TWEED
SHIRE COUNCIL

Planning Committee Meeting Thursday 6 August 2015

ITEM	PRECIS	PAGE
REPORTS THROUGH THE GENERAL MANAGER		6
REPORTS FROM THE DIRECTOR PLANNING AND REGULATION		6
1	[PR-PC] Development Application DA14/0904 for a 28 Townhouse Development at Lot 2 DP 566095 No. 47 Champagne Drive, Tweed Heads South	6
2	[PR-PC] Development Application DA15/0422 for a 65 Lot Subdivision at Lot 1147 DP 1115395 Seabreeze Boulevard, Pottsville	65
3	[PR-PC] Development Application DA13/0401.01 for an Amendment to Development Consent DA13/0401 for Integrated Housing Comprising of 12 Dwellings at Lots 35 and 36 DP 1145386 Cylinders Drive, Kingscliff	74
4	[PR-PC] PP10/0007 Mooball Planning Proposal	77
5	[PR-PC] Work Priorities Plan - Strategic Planning & Urban Design Unit	92
6	[PR-PC] Stormwater Issues - Gladioli Avenue and Terranora Road, Terranora	100
7	[PR-PC] Stormwater Issues Tweed Shire	106
8	[PR-PC] Variations to Development Standards under State Environmental Planning Policy No. 1 - Development Standards	110

DRAWING NO.
DA-13

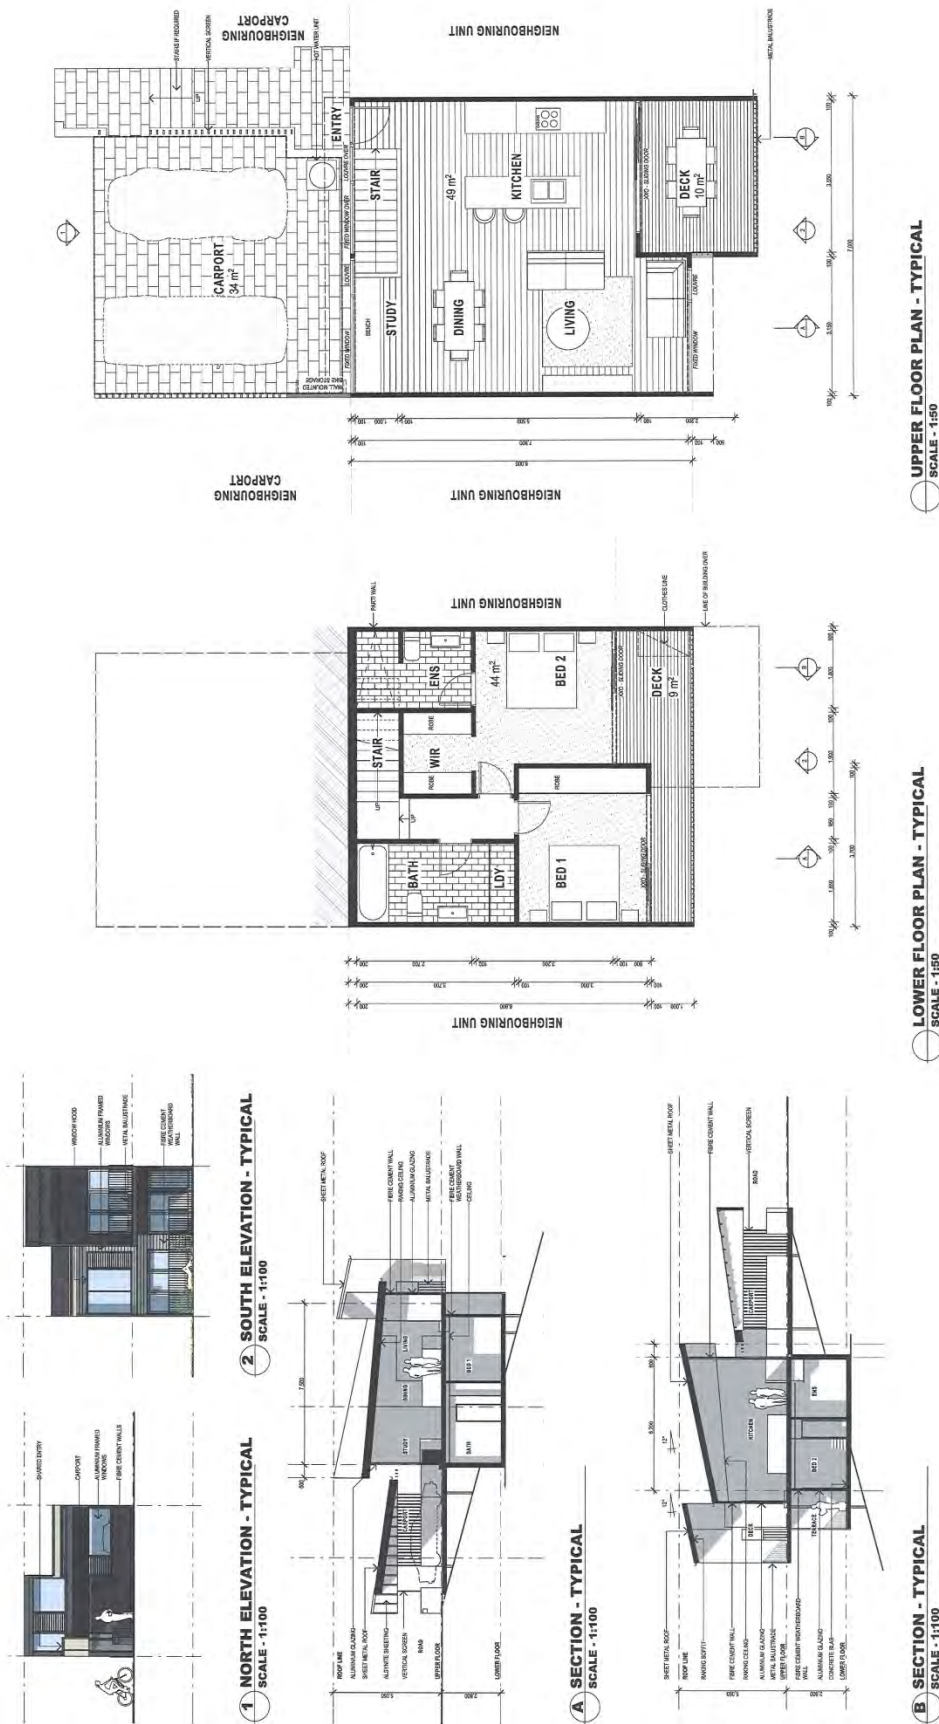
The amended plans for Dwellings 1-13 (dwelling type A), still requires a cut of between 1.5m to 2.85m and also includes the construction of part of the lower level being beuilt below natural ground level. The development of Dwelling Type A does not offer any form of stepping or suspended flooring to accommodation the changes in level.

The proposed development exceeds the maximum cut of 1.0m and is not development referred to under control j (see further response below).

DRAWING NO.
 DA-16

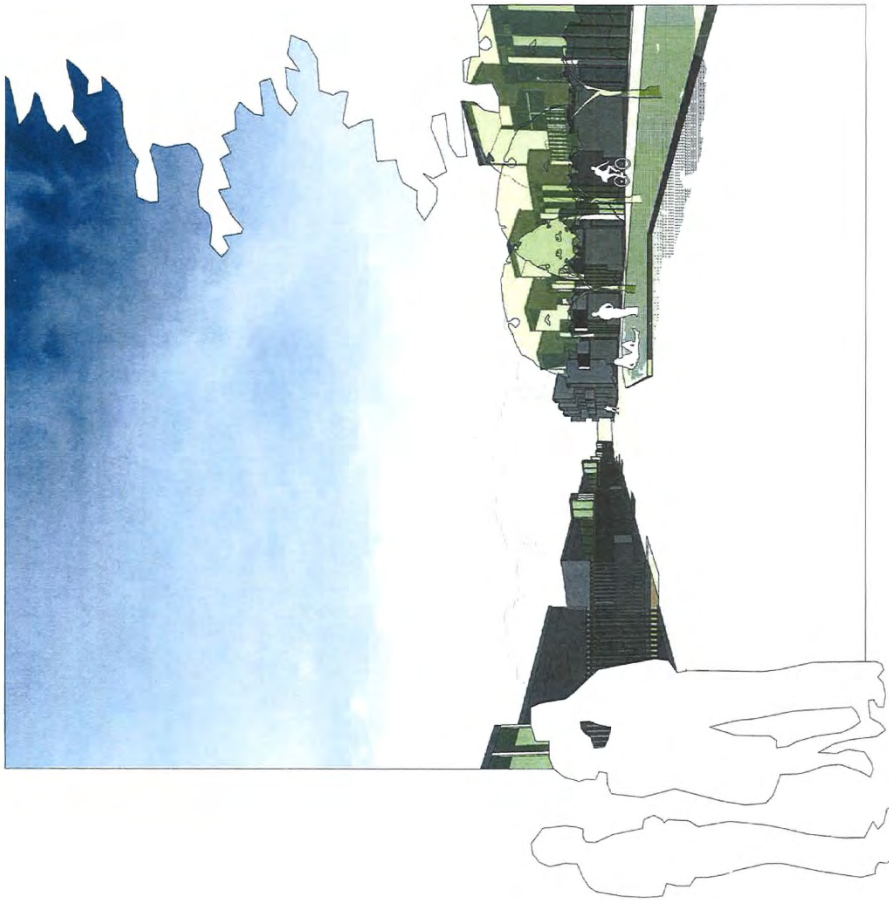
As shown on Dwg. No. DA-18 Issue A Services Plan dated 08/12/2014 prepared by Reddog Architects a broad area to the south of the site is described as 'Natural Drainage Mitigation Area'. A section of this area is occupied by native vegetation as detailed above (TVMS 207). From review of the application material there does not appear to be a detailed hydraulic/stormwater management plan clearly detailing the role/design of the 'Natural Drainage Mitigation Area'.

In conclusion Council's NRM unit raised no significant issues and advised that the requirement for a brief habitat restoration plan either as a stand-alone plan or component of the landscape plan detailing the following could have be conditioned:
